UNITED STATES PATENT AND TRADEMARK OFFICE

APPLICATION NO.	FILING DATE	FIRST NAMED INVENTOR	ATTORNEY DOCKET NO.	CONFIRMATION NO.
10/766,302	01/27/2004	Ares J. Rosakis	14850-002001	9346
20985	7590	02/24/2006	EXAMINER	
FISH & RICHARDSON, PC P.O. BOX 1022 MINNEAPOLIS, MN 55440-1022			TURNER, SAMUEL A	
			ART UNIT	PAPER NUMBER
			2877

Office Action Summary	Application No. 10/766,302	Applicant(s) ROSAKIS ET AL.	
	Examiner Samuel A. Turner	Art Unit 2877

DETAILED ACTION

FIG_1

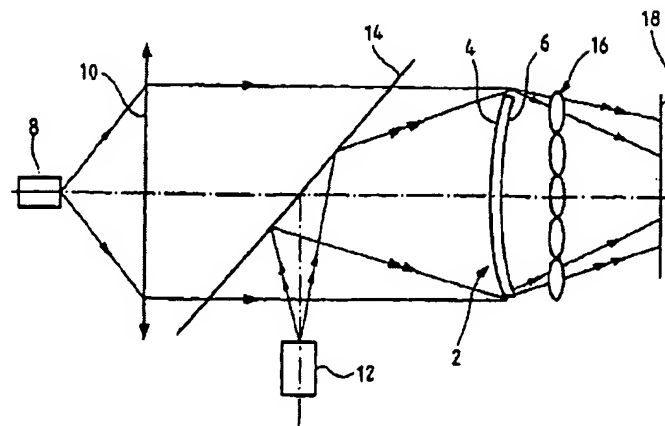
Claims 8, 9, 13, 14, 16-18 are rejected under 35 U.S.C. 102(b) as being clearly anticipated by Devie et al(WO 02/16902). See U.S. 6,909,498 for an English translation.

With regard to claim 8, Devie et al teach a method, comprising:

directing an optical reflection off a sample plate into a first optical shearing interferometer to obtain a first map of wavefront slopes of the optical reflection indicative of the reflective surface of the sample plate(page 6);

directing an optical transmission through the sample plate into a second optical shearing interferometer to obtain a second map of wavefront slopes of the optical transmission wavefront indicative of the variations in the optical path across the sample plate(page 6); and

processing the first and second maps to obtain information on the sample plate(page 6).

Fig. 1. New interferometer, consisting of two Ronchi phase gratings in series.

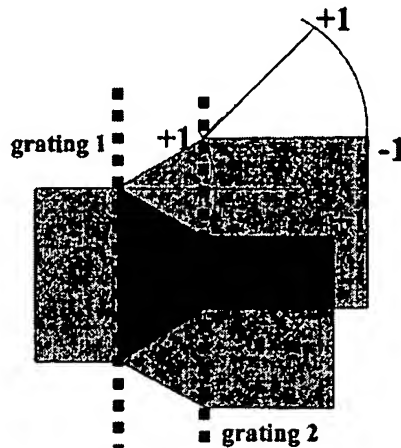
However, Schreiber et al teach a two grating interferometer, an CGS device, wherein both the lateral and the axial movement of one grating is adjusted with respect to the other grating (page 5323, section 3).

With regard to claims 2-4, 10, 12, 19, and 20, Devie et al fails to teach specifically wherein the first and the second optical shearing interferometers are coherent gradient sensing (CGS) devices.

It would have been obvious to one of ordinary skill in the art at the time the invention was made to use any known shearing interferometer, including the two grating lateral shearing interferometer of Schreiber since the Schreiber grating allows both phase control and phase scanning (section 3).

FIG. 1

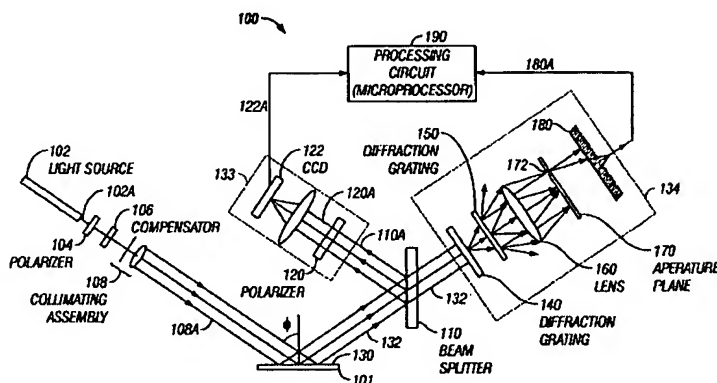
With regard to claim 15, Devie et al fail to teach any polarization control. However, Boyd et al teach placing a polarizer 104 between the source 102 and the lateral shearing interferometer 134.

It would have been obvious to one of ordinary skill in the art at the time the invention was made modify the Devie apparatus by placing a polarizer between the source and the lateral shearing interferometer in order to control the polarization of the incident light beam to provide ellipsometry measurements as found in Boyd.
